ADDENDUM NO. 2

Kau Water System Improvements – Phase 1

IFB No.: IFB-20-HHL-019

4
S-5
PIPE GRATE DETAIL
NOT TO SCALE

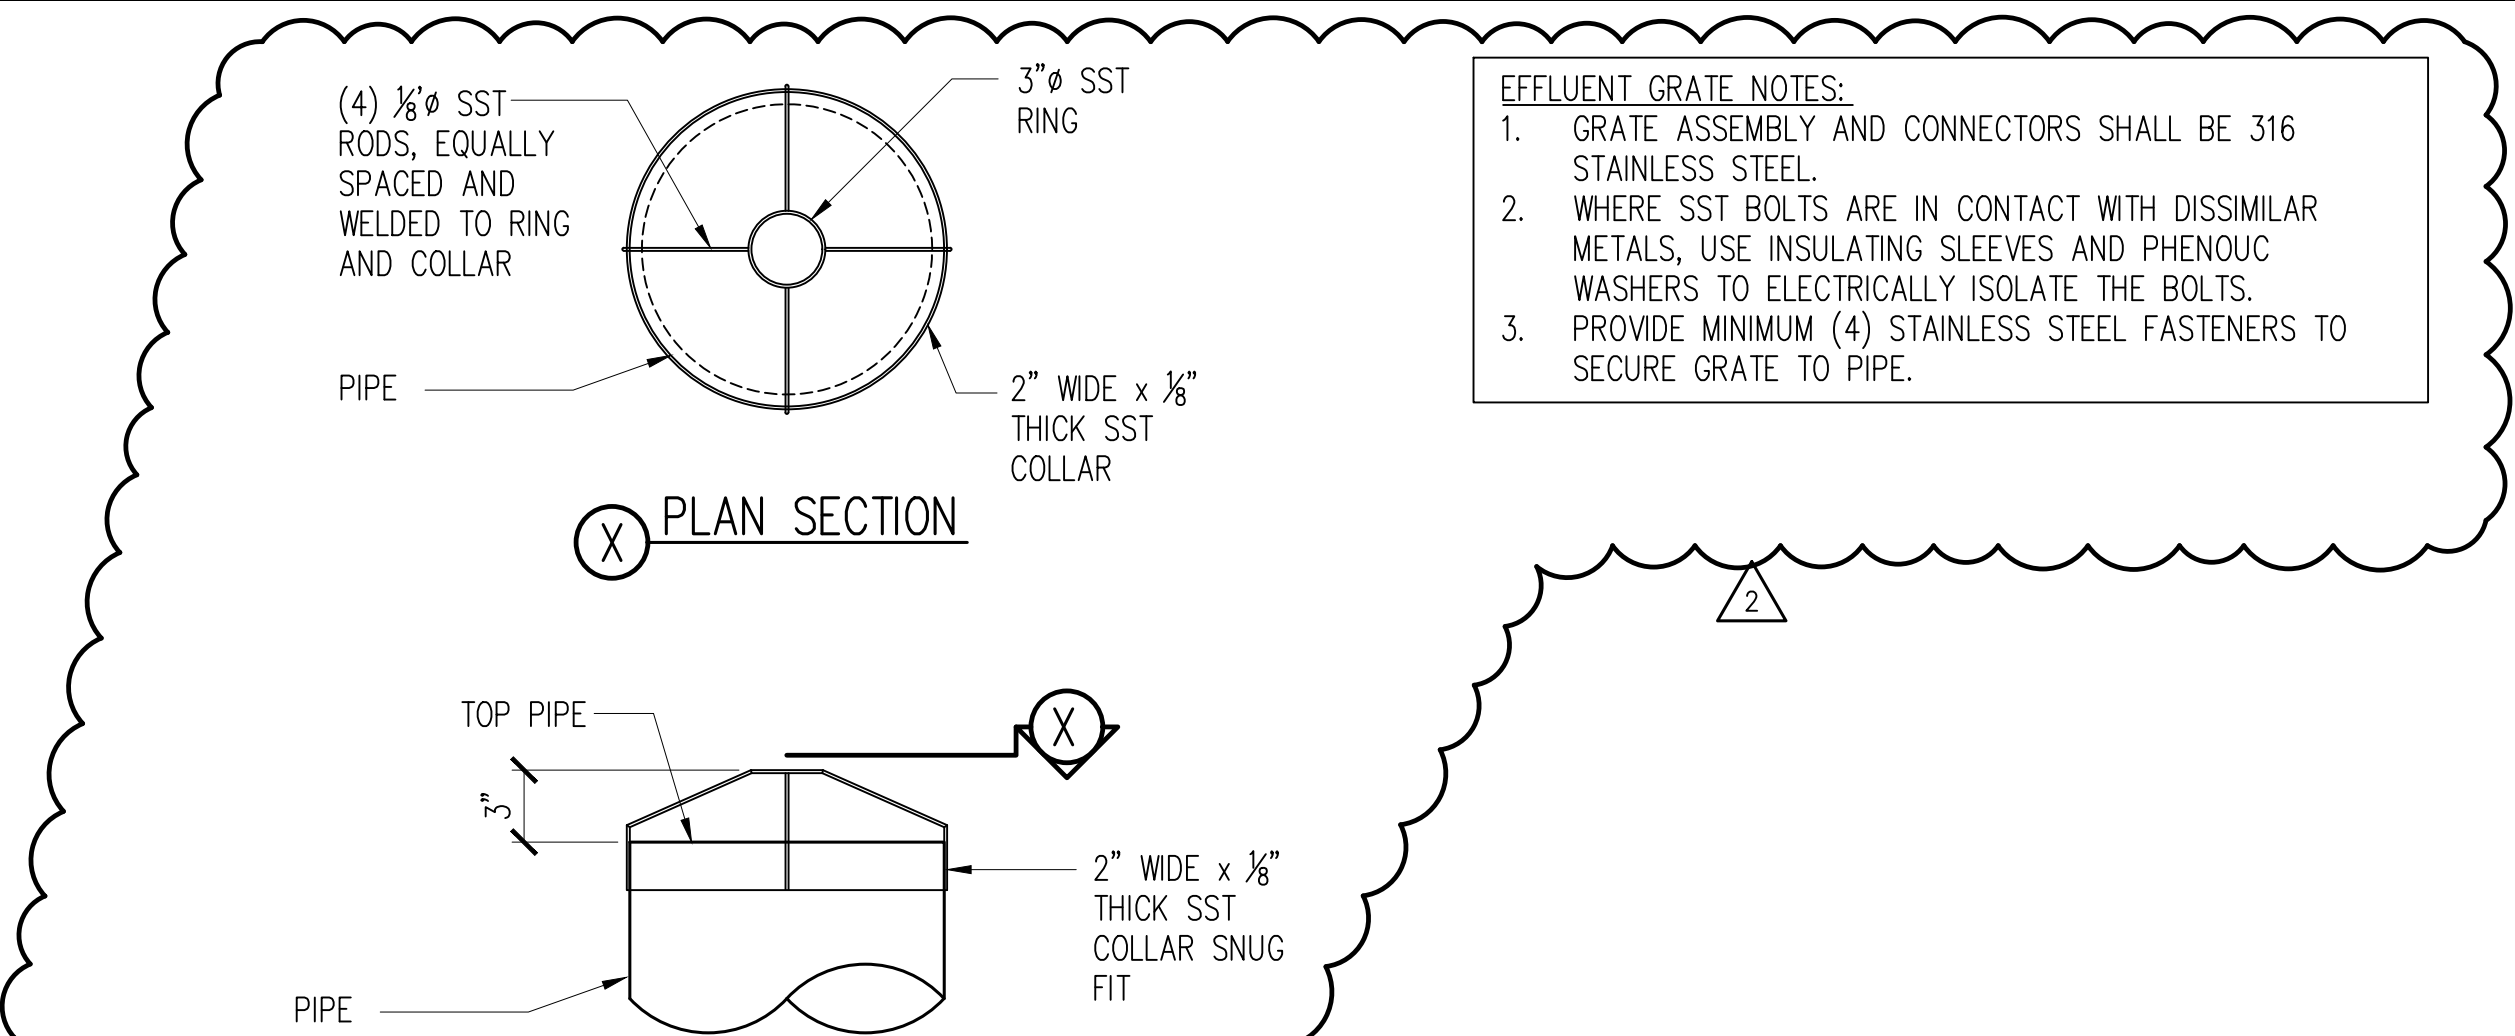
9. PLANS: DETAIL 4/S-5 – Revised pipe grate detail.

1
S-7
RESERVOIR SECTION
SCALE: 1/4" = 1'-0"

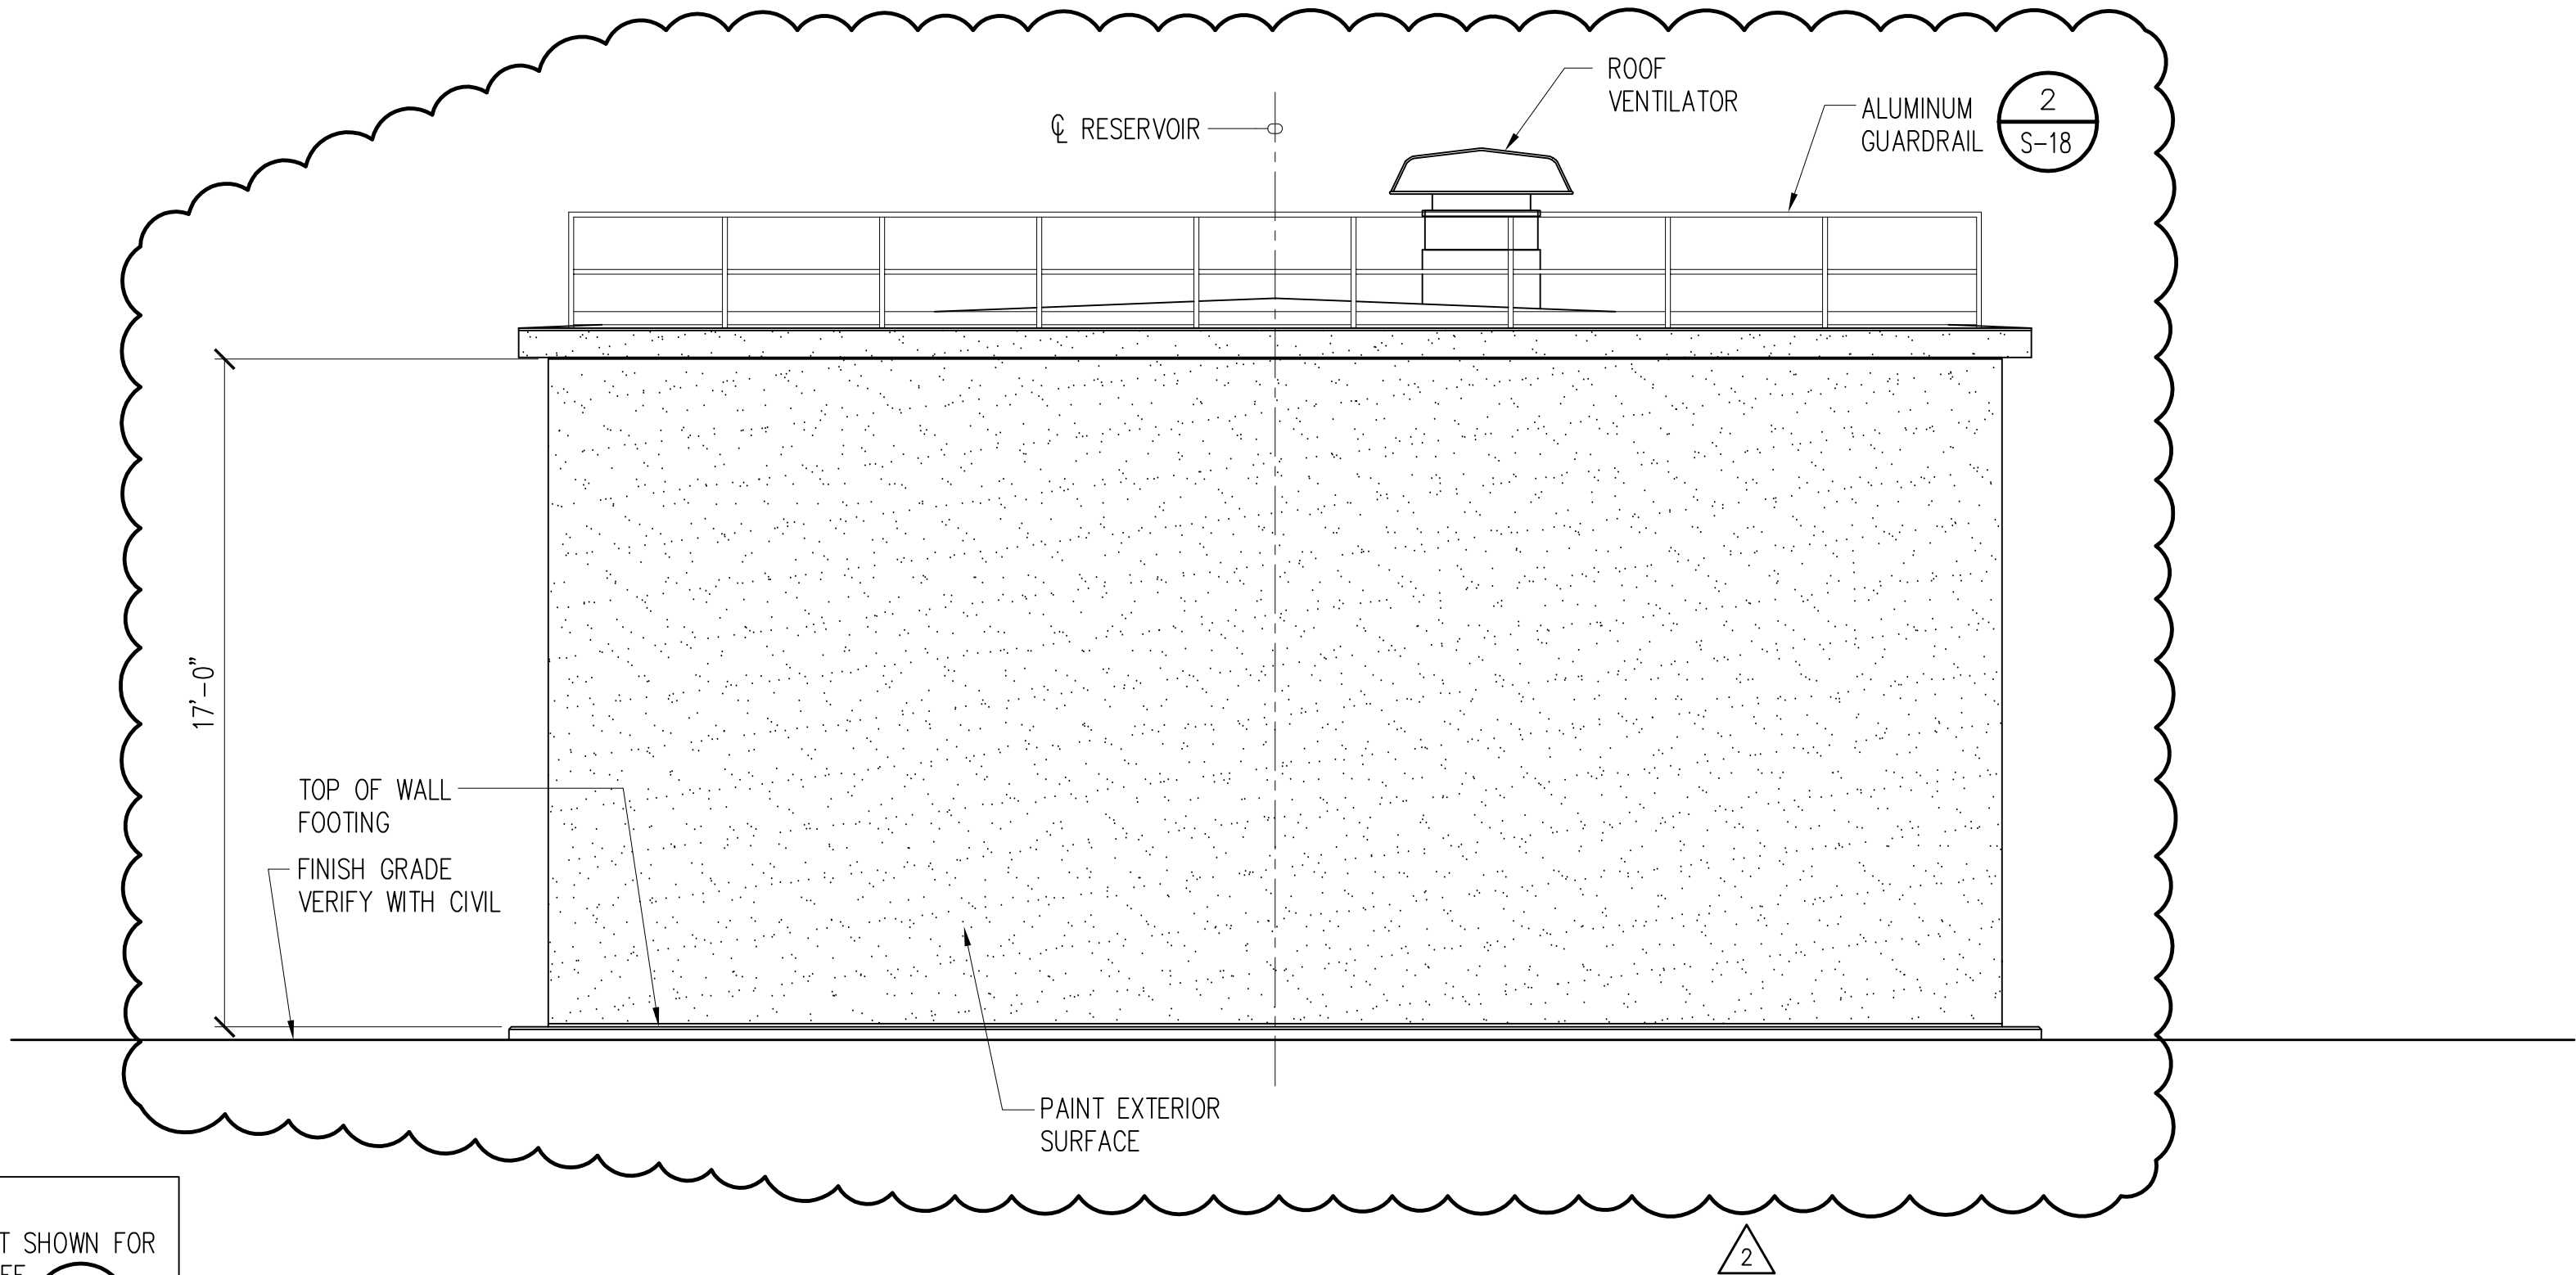
12. PLANS: DETAIL 1/S-7 – Removed concrete roof curb and added roof overhang; removed fluid-applied roof coating; indicated wording “2% slope”; added wording “with broom finish” to “9” roof slab” callout.

REINFORCED CONCRETE RESERVOIR -
TYPICAL WALL SECTION

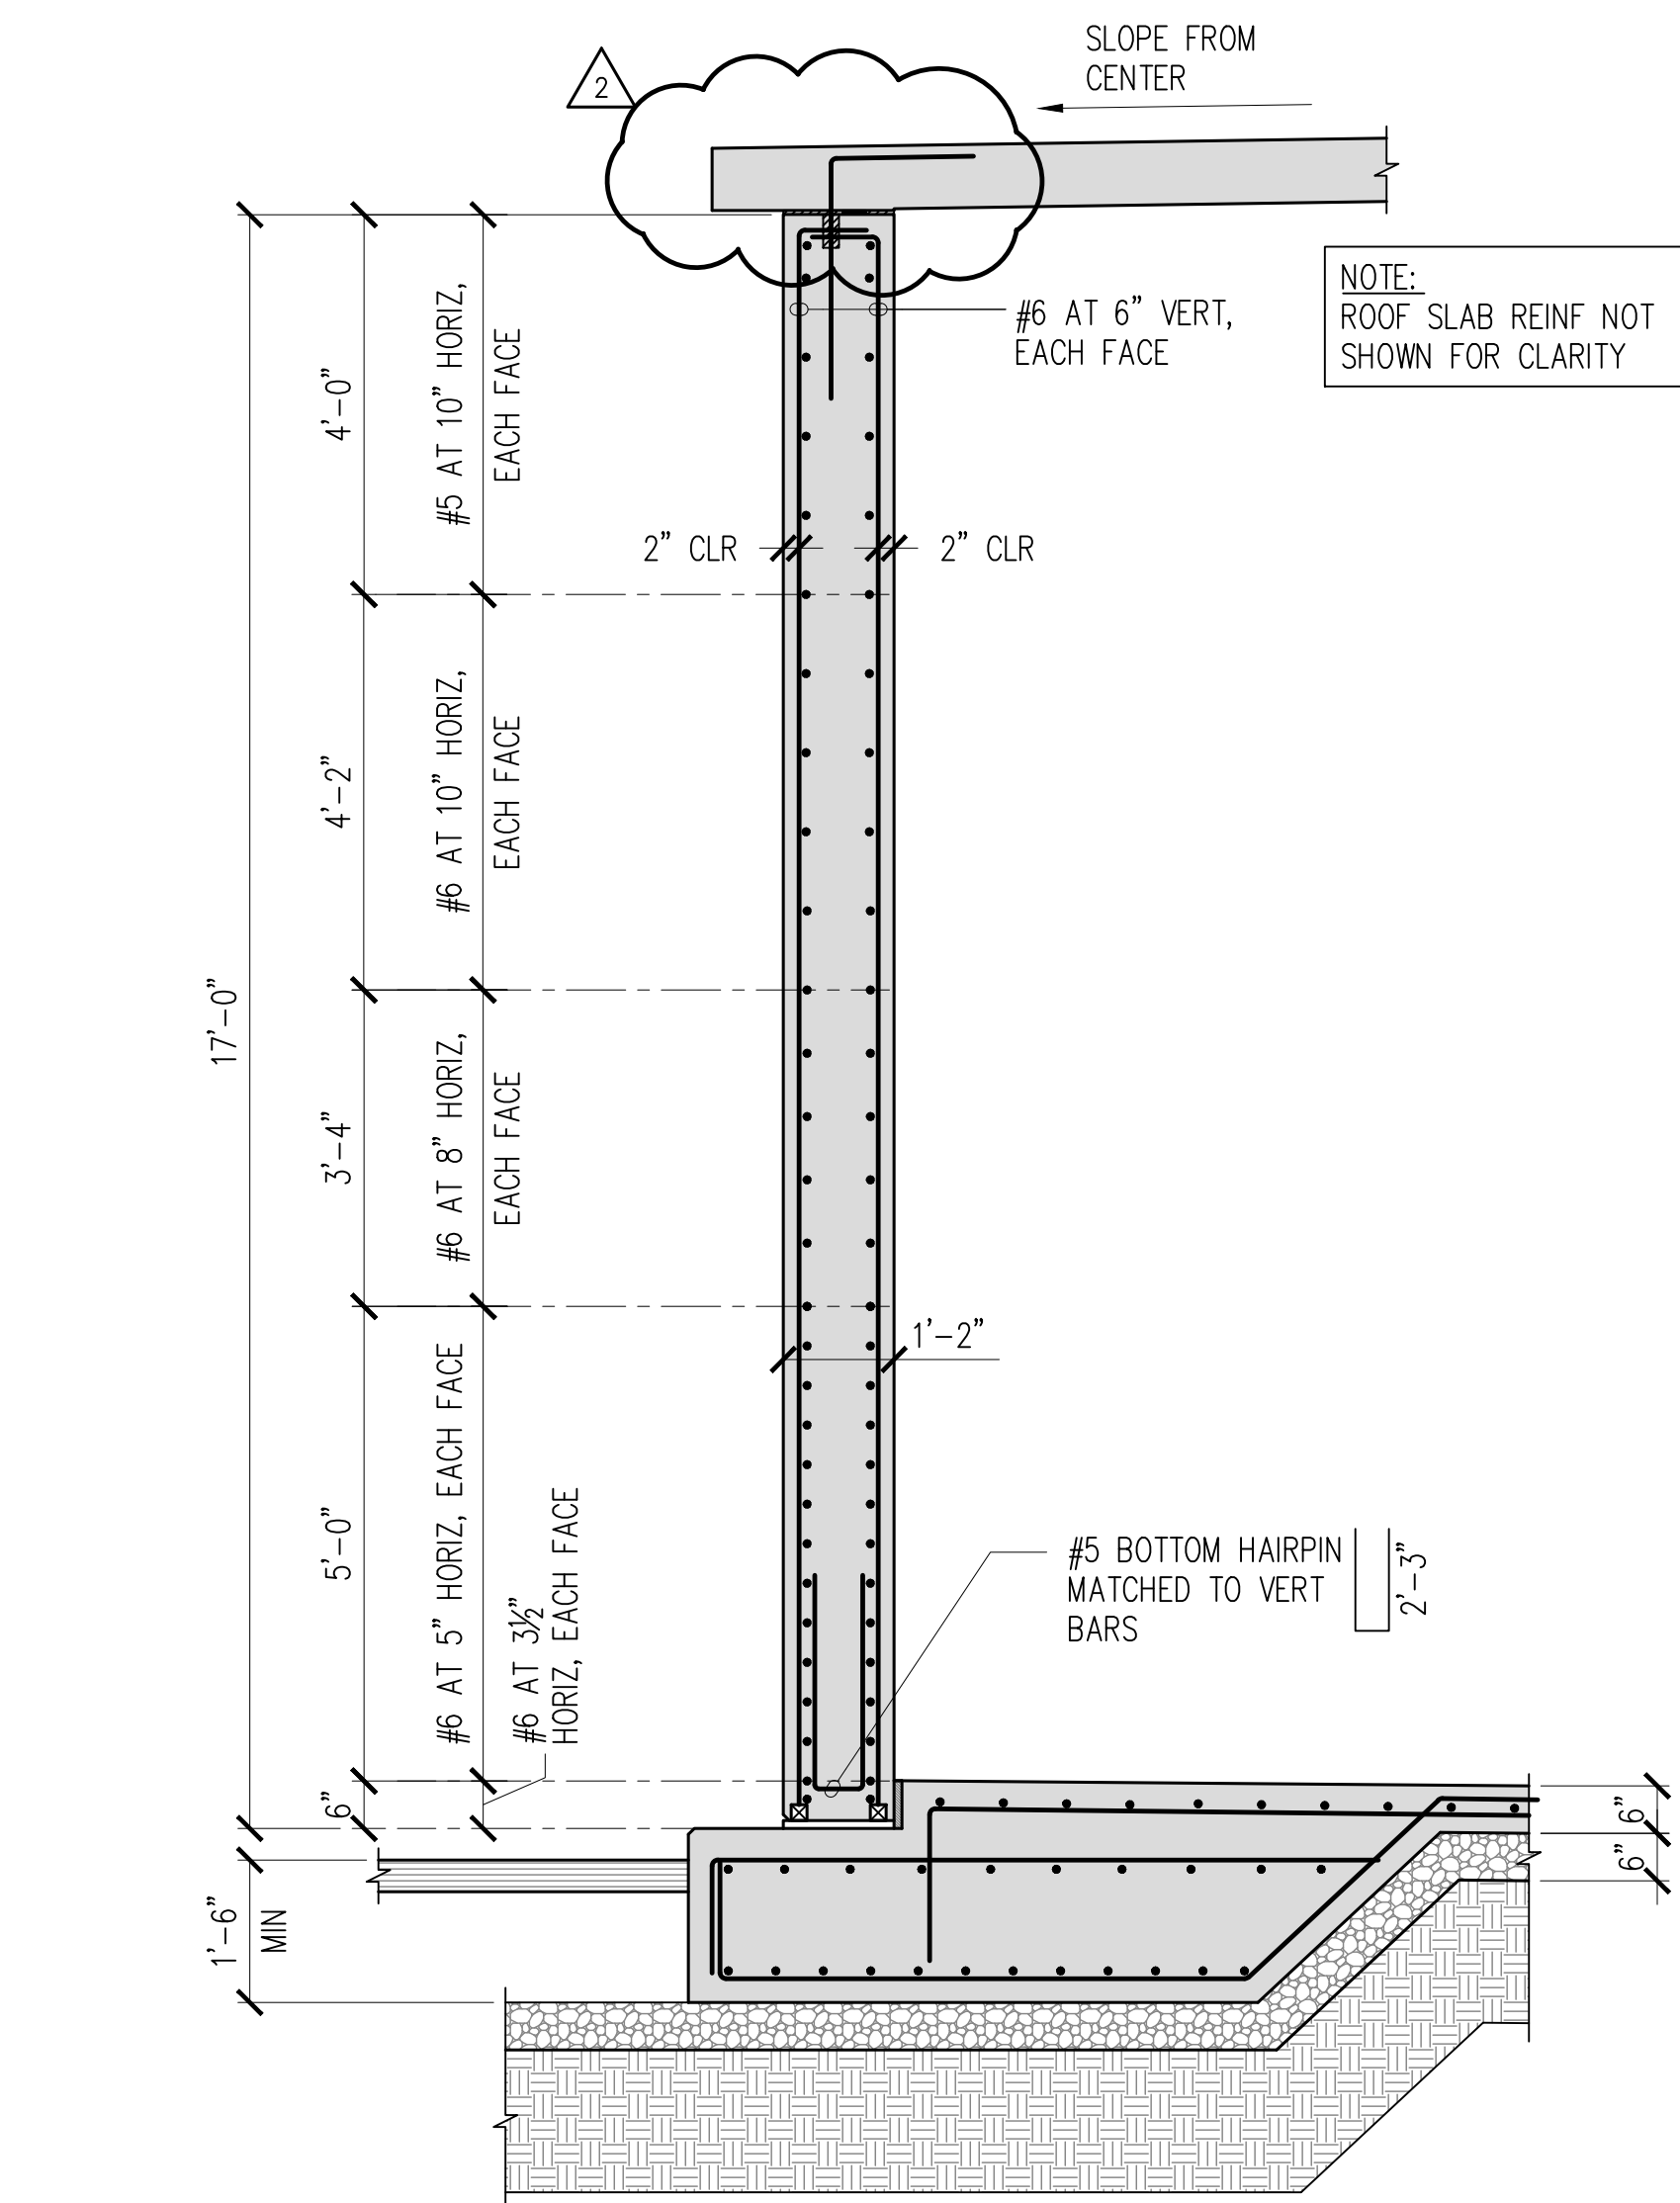
14. PLANS: DETAIL 1/S-8 – Removed concrete roof curb and added roof overhang.
15. PLANS: DETAIL 1/S-9 – Removed concrete roof curb and added roof overhang.
